**DEVELOPMENT CONSENT AUTHORITY
DARWIN DIVISION**

AGENDA ITEM: **1** **MEETING DATE:** 03/07/2026 **FILE:** PA2026/0165

APPLICATION PURPOSE:	Dwelling-multiple (14 x 2 bedroom) in a three storey building
SUBJECT SITE:	Lot 1861 (85) Progress Dr, Nightcliff, Town of Nightcliff
ZONE:	MR (Medium Density Residential)
SITE AREA:	1740 m ²
APPLICANT	Cunnington Rosse Town Planning and Consulting Senior Planning Consultant - Rory Mackay
PERSONS ON WHOSE BEHALF THE APPLICATION IS MADE	Landowner
LANDOWNER	Tsougranis Developments Pty Ltd Director - Paul Tsougranis
ANY PERSON WITH AN AGREEMENT TO ACQUIRE AN INTEREST IN THE LAND	None

B	FRONT BOUNDARY EGRESS GATES MOVED TO OPEN WITHIN BOUNDARY. FRONT FENCE RELOCATED AROUND ELECTRICITY EASEMENT	17.06.26
A	ISSUED FOR DA APPLICATION	07.05.26
ISSUE	AMENDMENT	DATE

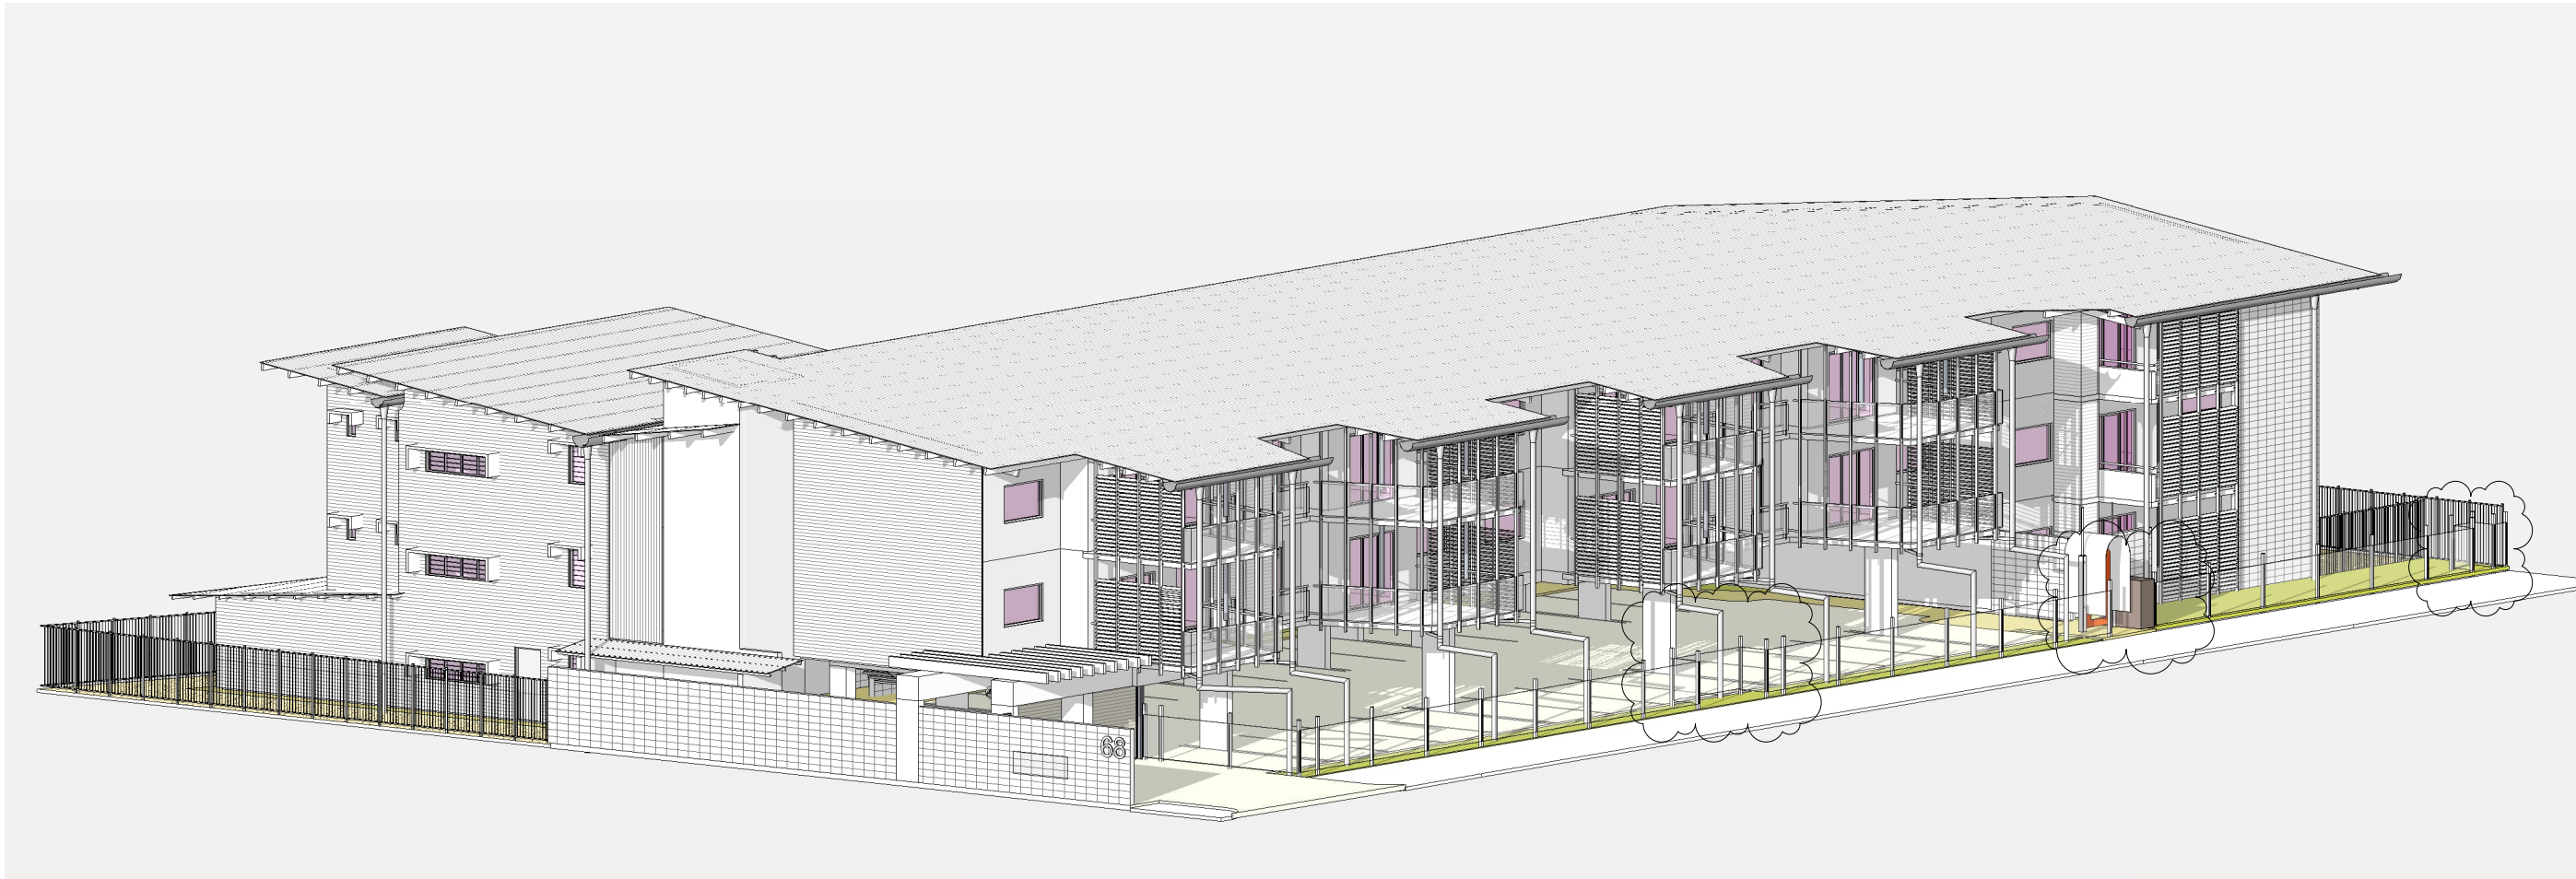
The Power and Water (Power Section) raised the matter that the proposed 1.5m high fence blocking the full access to the existing electricity easement, where a revised site plan is required to leave the front boundary clear around the easement.
